Title: Advisory Committee on Reactor Safeguards
US-APWR Subcommittee Meeting

Date: Friday, May 27, 2011

MEETING OF THE US-APWR SUBCOMMITTEE

DCD CHAPTER 5: REACTOR COOLANT AND CONNECTING SYSTEMS

5.3.2 RV Pressure-Temperature Limits

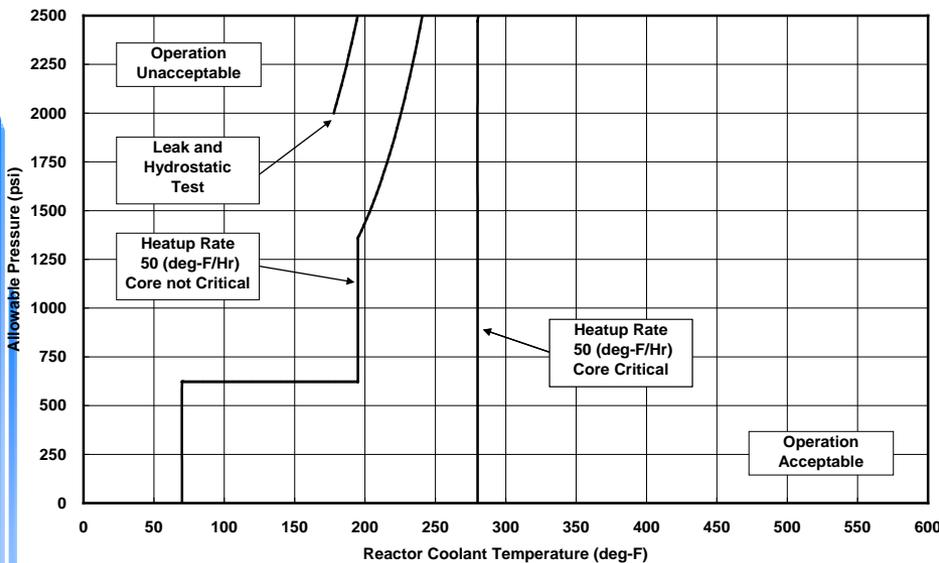
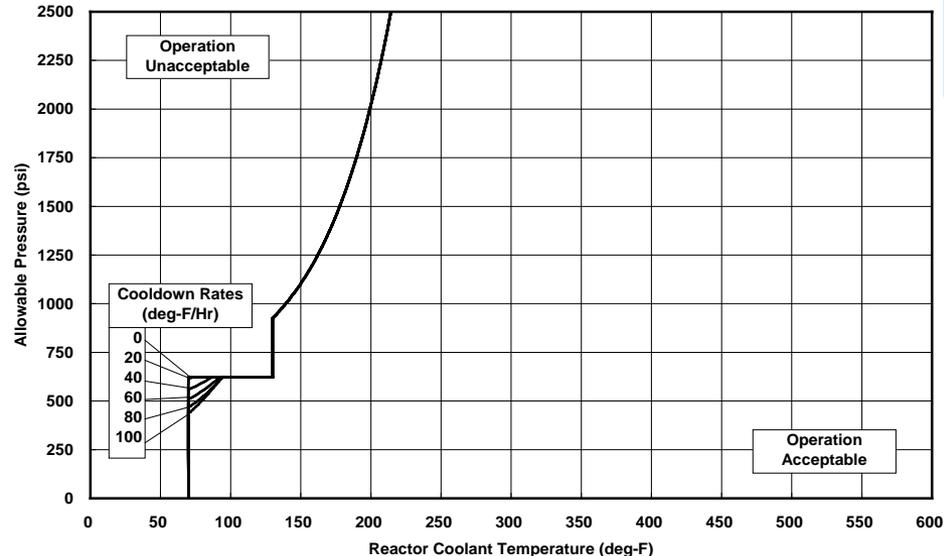
14 In this case, there are let's see two open
15 items. The first one, let me just read it. Generic
16 P-T Limit Report with bounding P-T limit curves based
17 on bounding material properties and projected fluence,
18 following the guidelines of GL96-03. This was a RAI
19 question but the answer was not factored into the SER.
20 But it was answered, the second bullet there says MHI
21 submitted this P-T report and it just hasn't been
22 incorporated at this time. That's all. The next
23 item, the P-T limit for the reactor vessel are based
24 on evaluation of the reactor vessel beltline and
25 closure flange reasons. Explain how this relates to

1 the nozzles and the remainder of the RV. The response
2 is that the RV fracture mechanics evaluation addresses
3 limits for the entire RV including nozzles is in
4 process. The fracture mechanics analysis comes after
5 the stress analysis and there's a lot of, the stress
6 analysis is not yet complete of all of these parts.
7 But this is also an in process and I think consistent
8 with. The beltline region was presented first because
9 it was generally most interesting information to start
10 with. Let's go to the next slide.

5.4.1 Reactor Coolant Pumps

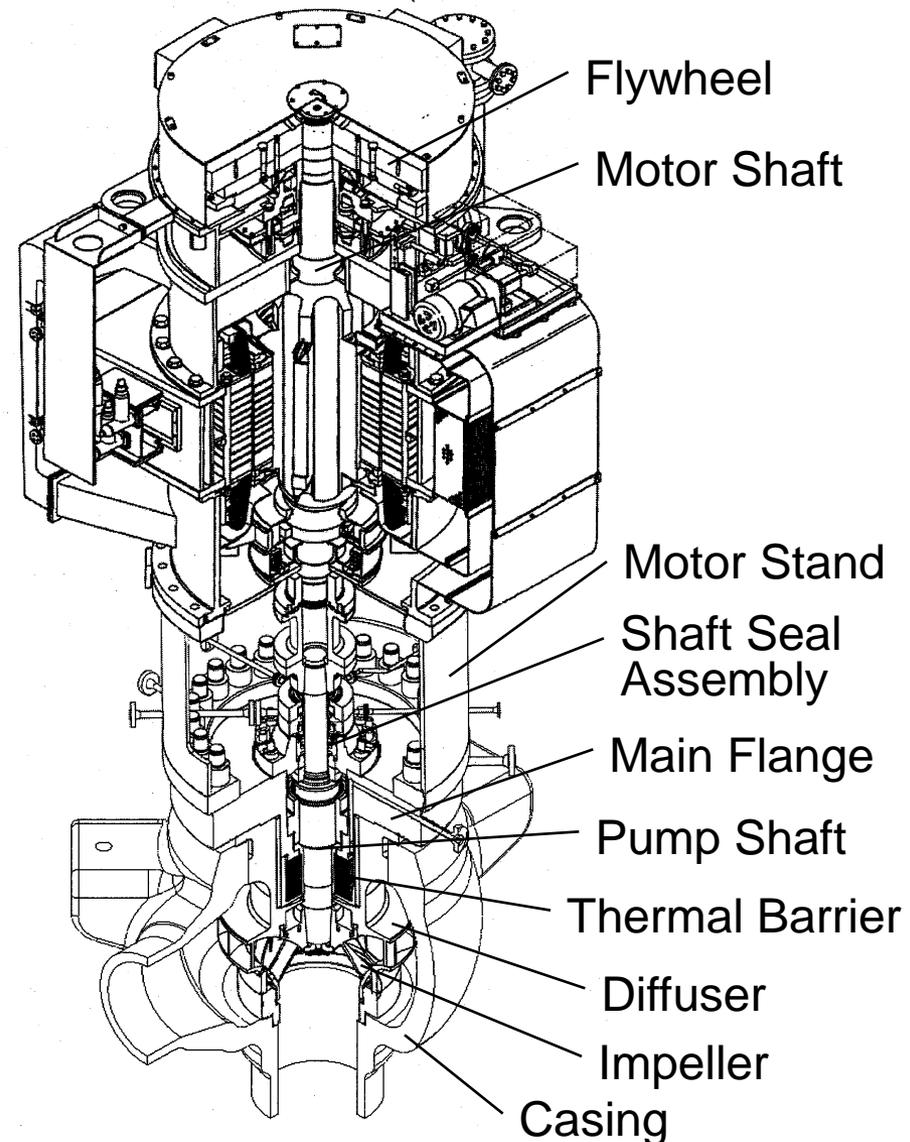
11 CHAIRMAN STETKAR: I had a question also
12 on the flywheel integrity and this may be obviated by
13 the probabilistic fracture mechanics analysis that was
14 done. The nominal speed of the reactor coolant pump
15 is 1200 rpm and for an overspeed during LOCA analyses,
16 you take credit for the leak before break analysis, at
17 least in the deterministic analysis to justify that
18 the limiting overspeed would be 1500 rpm, 25 percent
19 larger. I didn't look the probabilistic fracture
20 mechanics. Do they look at ranges of overspeed
21 greater than 1500 rpm in that analysis Bill?

19 MR. WILSON: All right. The next slide.
20 Thank you. This one is the third open item related to
21 the pump. And the title was RCP operability without
22 component cooling water. The question was since the
23 component cooling water, CCWC supplies cooling water
24 to both chemical volume control system, pump motors,
25 seal water cooler and oil cooler and the thermal

Open Item Subject	Description of Open Item
<p>SER 05.04.01.01-2 RAI 05.04.01.01-5 & 8 DCD 5.4.1.1 "Pump Flywheel Integrity"</p>	<ul style="list-style-type: none">➤ The staff requested additional information:<ul style="list-style-type: none">• Critical flaw size associated with 1500 rpm design speed• Reliable detection threshold for Ultrasonic Testing (UT) inspection ➤ MHI response is being prepared at this time:<ul style="list-style-type: none">• Critical flaw > 3" at 1500 design speed• UT threshold for reliable detection is much smaller
<p>SER & RAI 05.04.01.02-1 DCD 5.4.1.2 "RCP Operability without Seal Injection Water"</p>	<ul style="list-style-type: none">➤ Additional information requested:<ul style="list-style-type: none">• Is there a low-flow alarm in the Main Control Room (MCR)?• How long can the RCP operate without seal injection water? ➤ MHI response is being prepared at this time:<ul style="list-style-type: none">• There is a low-flow alarm in the MCR from a flow meter in the seal injection line• Subsection 5.4.1.3.3 refers only to loss of seal injection flow. The RCP can operate indefinitely without seal injection water because of the redundant cooling offered by the thermal barrier heat exchanger.

Open Item Subject	Description of Open Item
<p>SER & RAI 05.04.01.02-2 DCD 5.4.2.1 "RCP Operability without Component Cooling Water"</p>	<ul style="list-style-type: none">➤ Since the Component Cooling Water System (CCWS) supplies cooling water to both Chemical and Volume Control System (CVCS) (pump motor, seal water cooler, and oil cooler) and the thermal barrier, explain the meaning of "loss of CCW".➤ Identify the DCD section dealing with operator instructions for loss of CCW and seal injection.➤ MHI Response is being prepared at this time:<ul style="list-style-type: none">• Subsection 5.4.1.3.4 is intended to address loss of CCW to the motor bearing oil coolers or the thermal barrier heat exchangers independent of each other. It will be rewritten to make this clearer. "Loss of CCW" in subsection 5.4.1.3.4 does not mean "loss of all CCW."

1 response is in process at the moment. However, the
2 answers are straightforward. There is a flow alarm in
3 the main control room from a flow meter in the seal
4 injection line. And subsection 5.4.1.3.3 refers only
5 to the loss of seal injection flow. The RCP can
6 operate indefinitely without the seal injection water
7 because of the redundant cooling offered by the
8 thermal barrier heat exchanger. And I would just add
9 that indefinitely the DCD text says maintain safe
10 operating temperatures and operates safely for safe
11 shutdown of the pump. So, but really the redundant
12 cooling is present. But that was the answer, is the
13 answer being constructed.

5.4.11 Pressurizer Relief Tank

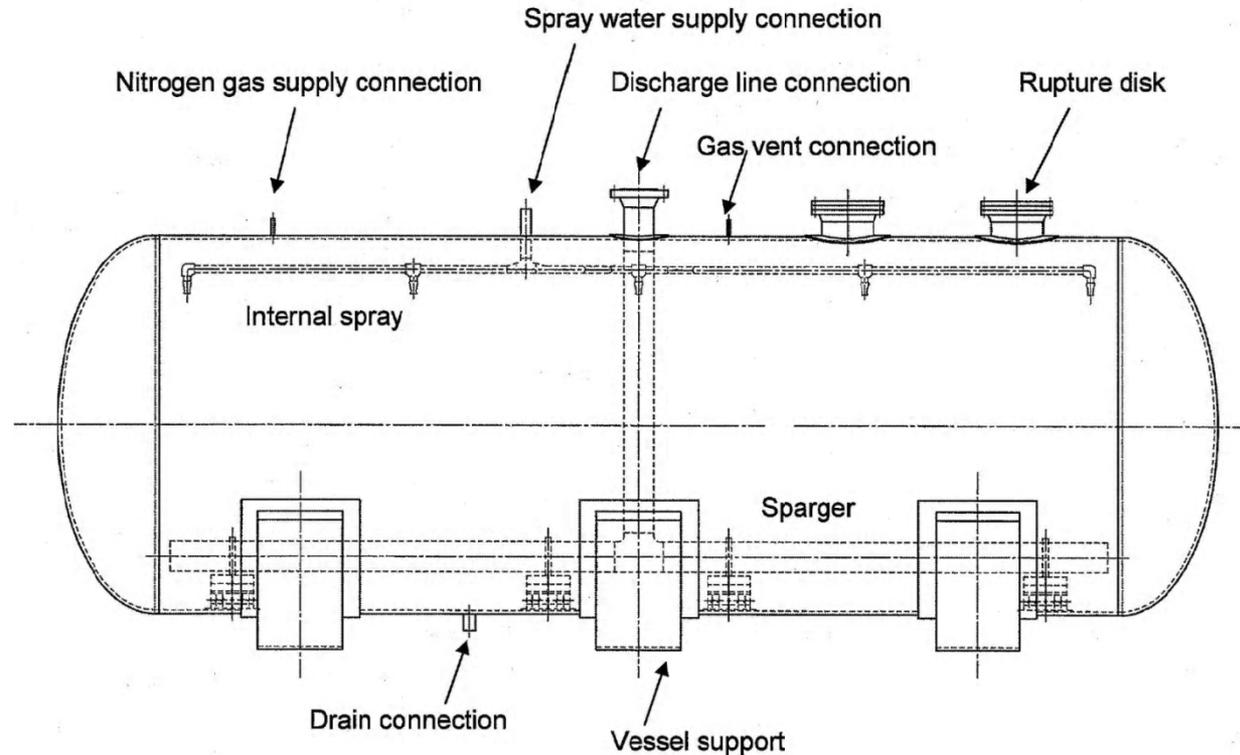
14 There are two open, three open items on
15 this that relate to this section. The first one is
16 for item one. Provide information, additional
17 information about the PRT and the rupture disk.
18 Basically the question is rupture pressure versus the
19 PRT design pressure. Then the next is ruptured disk
20 flow capacity versus the combined capacity of the
21 pressurizer safety valves. And the third has to do
22 with the external pressure design or design pressure
23 for the PRT. These are just, I'm not sure of the
24 history but these questions came up at a time after
25 the SER was, I mean it didn't get answered before

21 Provide a description, this is the third
22 and only last open item on this, on the PRT, provide
23 a description and identify a reference where
24 satisfaction of Reg Guide 1.29 Position C.3 and SRP
25 Acceptance Criterion 2.F are addressed. These deal

1 that. We're working on a response but basically you
2 can see the information was readily available. The
3 rupture disk design pressure is 190 psi plus zero
4 minus five percent and the design pressure is 200
5 psig. So, the pressurizer safety valve maximum flow
6 which is in Chapter 5 is 432,000 pounds per hour and
7 there are four of them. And the rupture disk are
8 sized to a flow greater than this value. The PRT is
9 required to meet the ASME Section III rules for
10 external pressure. The delta P, design pressure is 15
11 psi. So, I anticipate this will go with, based on
12 these answers to those questions. The next open item
13 identify a reference and provide a description that
14 shows the PRT rupture disk did not pose a missile
15 threat. And the responses in preparation but the
16 rupture disks on the PRT form, they perform their
17 pressure relief function without producing a missile
18 of any type. So, I think this is one of the cases

5.4.7 Residual Heat Removal System

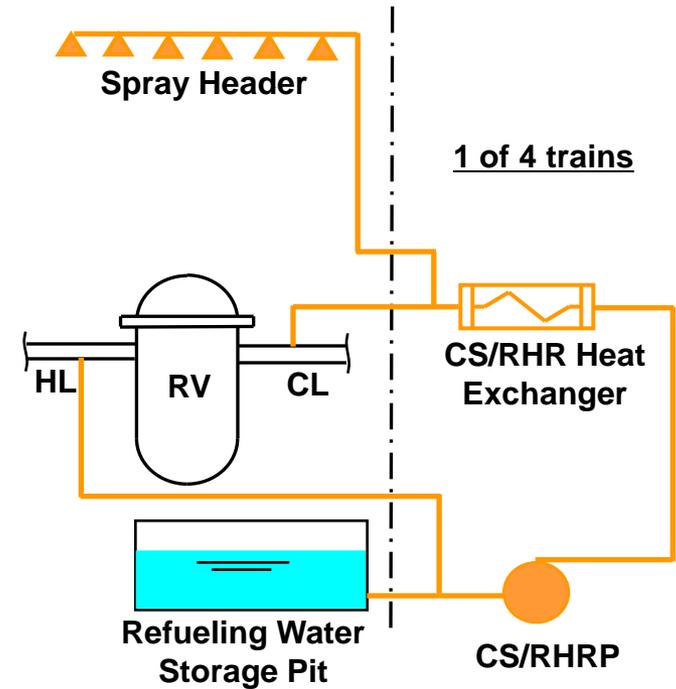
1 subject. Let me just comment that it says that
2 current treatment of gas accumulation issue with
3 respect to the USAPWR is substantial and appropriate.
4 However, important aspects of this issue, potentially
5 will remain unexamined and we will have more
6 discussion with the staff to clarify what is required
7 to deal with this.

16 CHAIRMAN STETKAR: Let's stop and go back
17 because I have several questions about the RHR system.
18 The first question, I have a couple of questions for
19 just technical facts. Is the RHR system for the
20 USAPWR initiated automatically or is it only manual?
